Tennessee Valley Authority
Regulatory Submittal for Kingston Fossil Plant

Addendum to Construction of Lateral Expansion Facilities- Phase 1
Implementation of Phases 1& 2 Ash Processing Dredge Cell/ Settling Area

ADDENDUM TO CONSTRUCTION OF LATERAL EXPANSION FACILITIES-PHASE 1

Re: Evaluation of Proposed Lateral Expansion Area Dredge Cell/Settling Pond
Kingston Fossil Plant
Harriman, Roane County, Tennessee

SKETCH SK-100 RLD 11-16-09

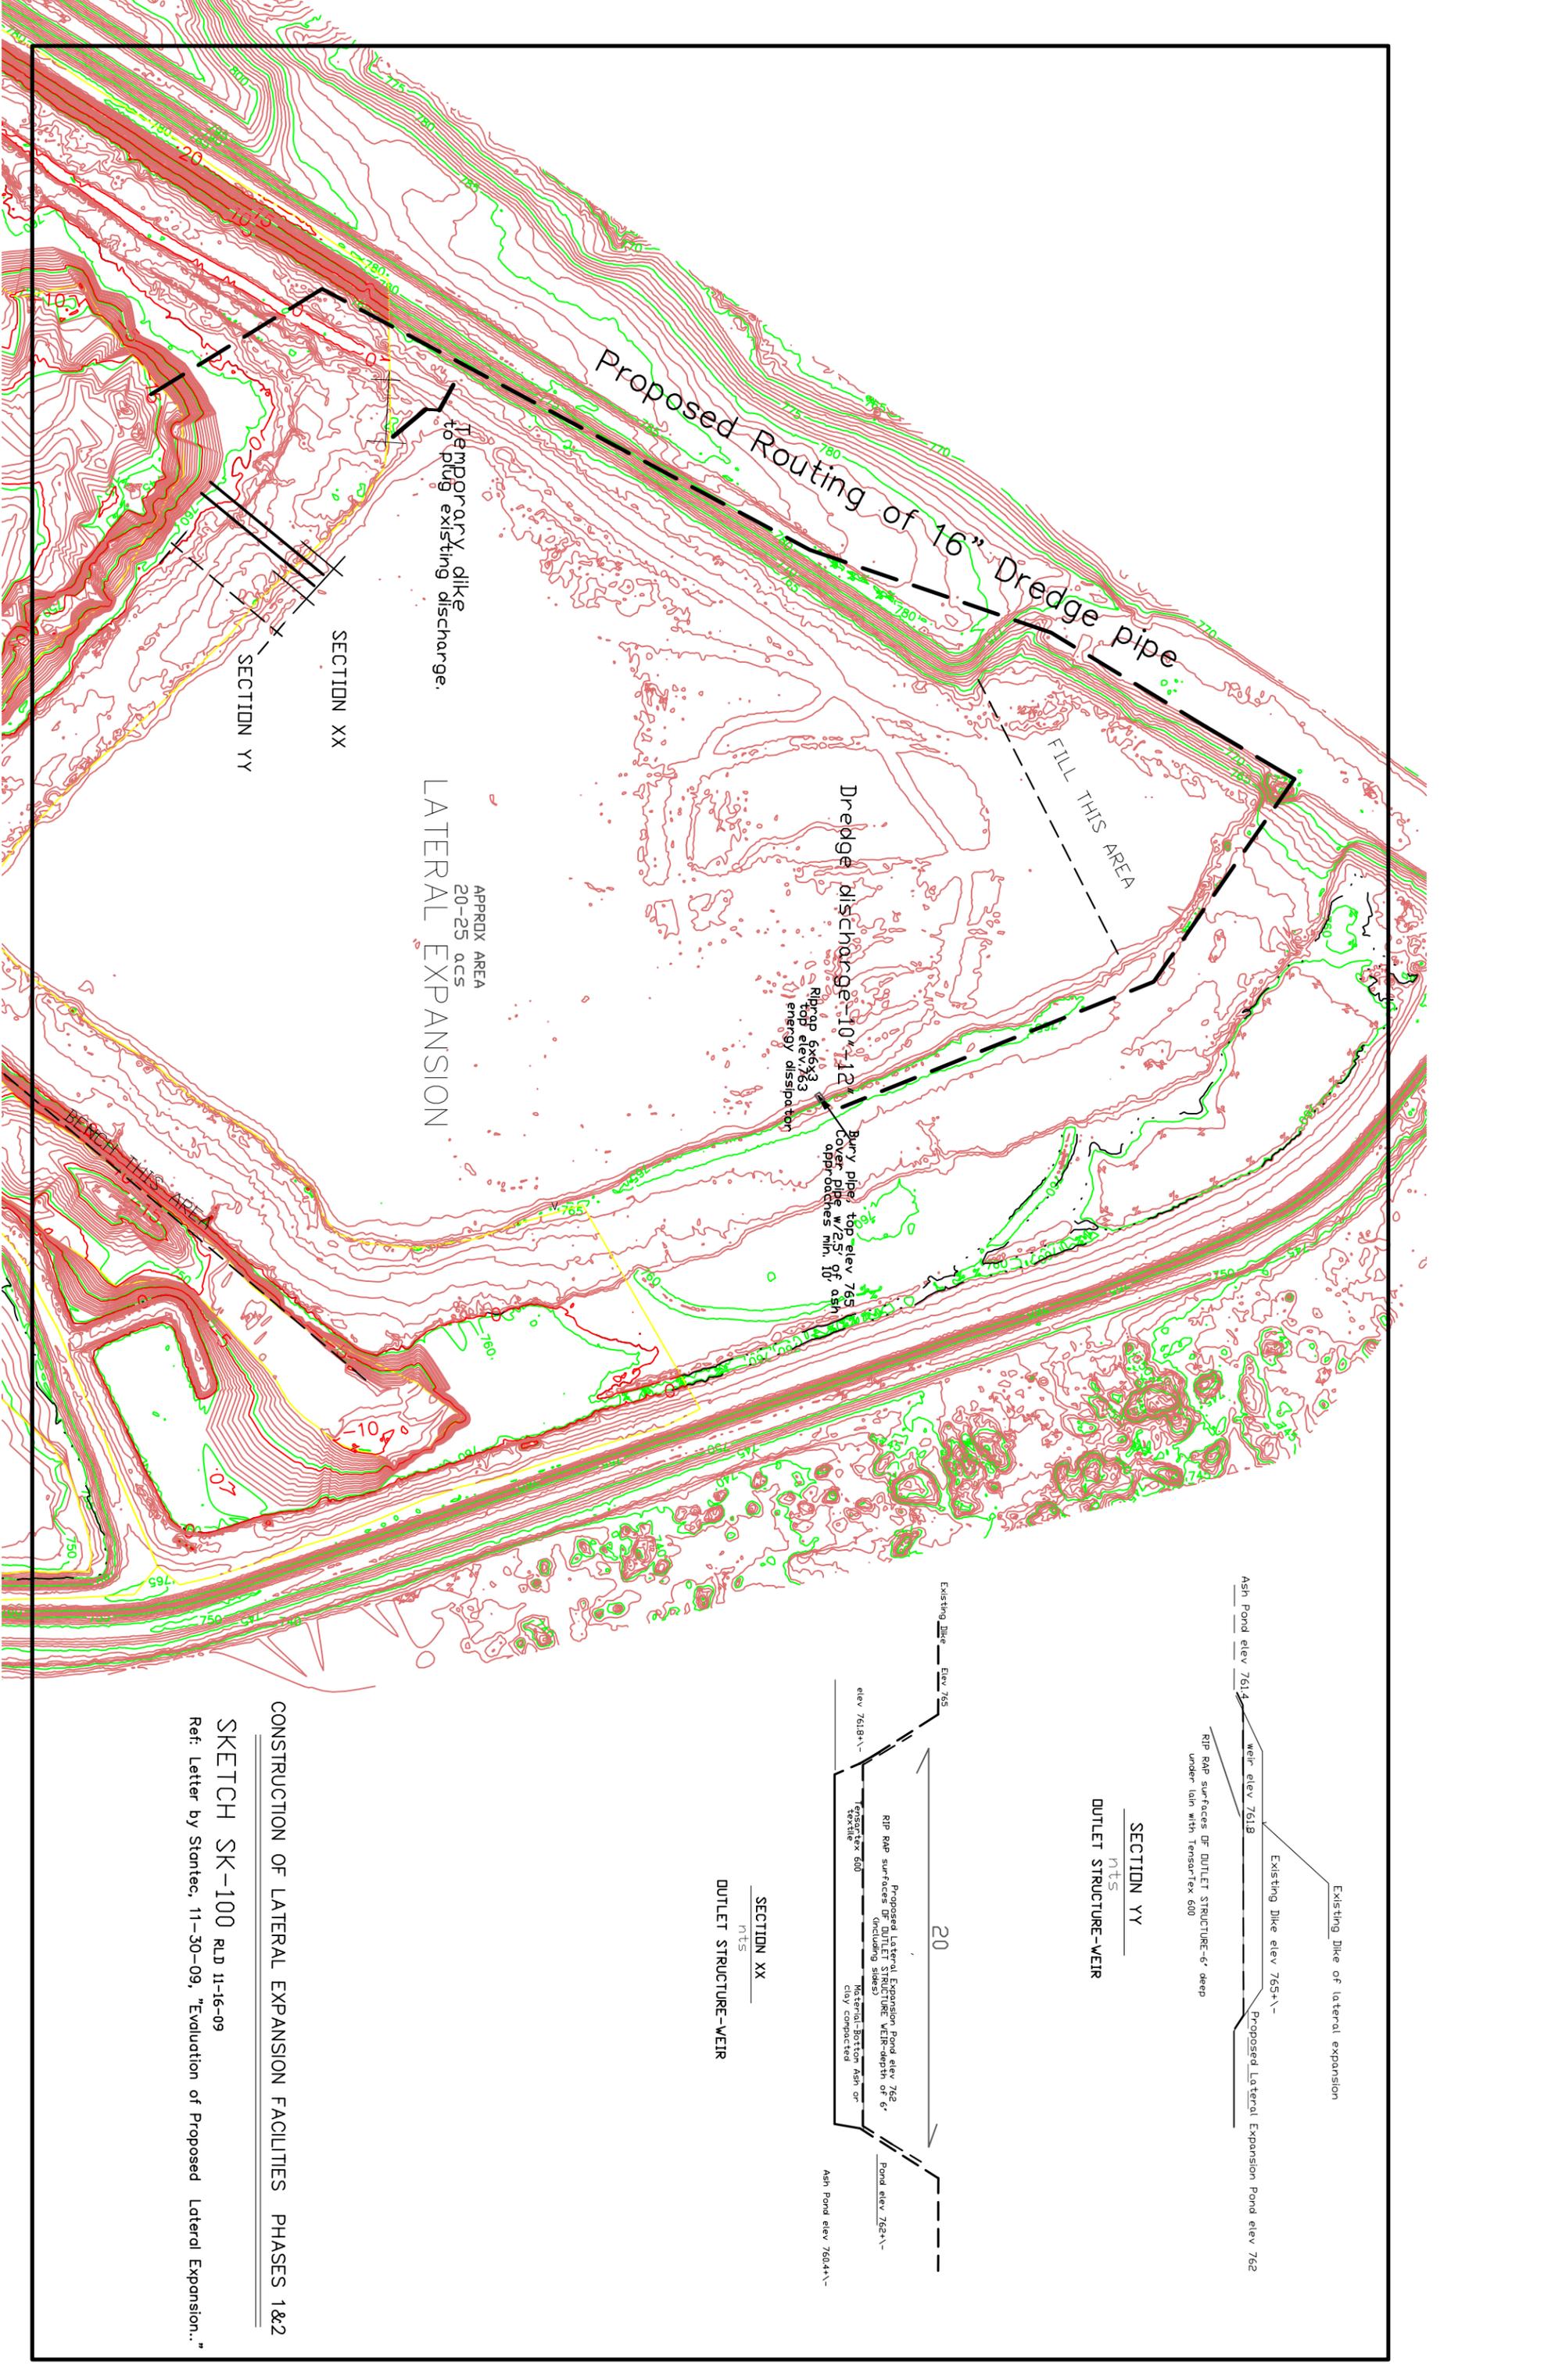
The intake into the lateral expansion will be located near the north east corner to maximize the the detention time and will be directed into a riprap check dam to dissipate the energy and prevent scouring. The pipe will be held in place by covering with two feet of ash for approximately 25'. Note attached Sketch # SK-100 for the facilities noted above as well as the pipe routing from the ash pond to the lateral expansion

The modifications to the expansion dike consists of creating a bench (decreasing the slope) on the south east side of the south east dike, building the expansion dike crest to a uniform elevation of 765, and filling in an area at the north corner of the expansion where it intersects Dike D. Note attached letters/reports by Stantec, dated 11-19-09 & 11-30-09, "Evaluation of Proposed Lateral Expansion Area Dredge Cell/Settling Pond", and e-mail clarification from Dan McQuinn referencing lateral expansion dated 12-2-09. The work will be carried out and
